# Access Compliance Report

## Public Rights-of-Way

Intersection ID: 10447	Main Street: SYLVANIA_AV	Cross Street: BANCROFT_ST	Location: NW
ADA ID: B7F52698DDAE	Ramp Type: Perp	Initial Pass/Fail: Fail	Overall Compliance: No
		Severity Score: 8.75

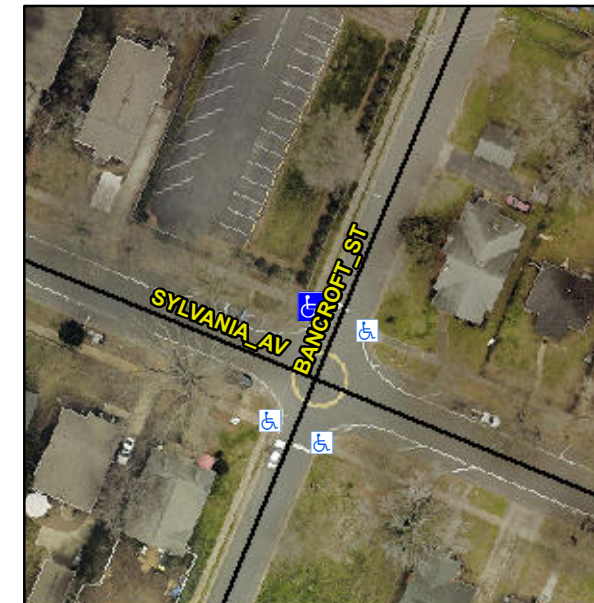
**Not Found, R304.5.1**

Compliance	Description	Data	Compliance	Description	Data
N/A	Ramp Length (in)	62.0	Yes	Ramp Slope (%)	8.0
No	Ramp Width (in)	42.0	Yes	Ramp XSlope (%)	1.7
N/A	Flare Type LT	N/A	N/A	Flare Type RT	N/A
N/A	Flare Slope LT (%)	N/A	N/A	Flare Slope RT (%)	N/A
N/A	Flare Traversable LT?	N/A	N/A	Flare Traversable RT?	N/A
N/A	Landing Length (in)	N/A	N/A	DWS Provided?	N/A
N/A	Landing Width (in)	N/A	N/A	DWS Contrast?	N/A
N/A	Landing Slope (%)	N/A	N/A	DWS Length (in)	N/A
N/A	Landing X Slope (%)	N/A	N/A	DWS Full Width?	N/A
N/A	Landing Curb? (Y/N)	N/A	N/A	DWS Offset (in)	N/A
N/A	Shared Landing?	N/A			
N/A	Gutter Ponding?	N/A	N/A	Gutter Slope (%)	N/A
N/A	Gutter Lip Ht (in)	0.5	N/A	Gutter X Slope (%)	N/A
N/A	Painted X Walk1?	No	N/A	Painted X Walk2?	N/A
	X Walk 1 Direction	To SE		X Walk 2 Direction	N/A
N/A	X Walk 1 Width (in)	N/A	N/A	X Walk 2 Width (in)	N/A
	X Walk 1 Slope (%)	1.6		X Walk 2 Slope (%)	N/A
	X Walk 1 X Slope (%)	1.1		X Walk 2 X Slope (%)	N/A

**Remove & Replace Entire Ramp.**
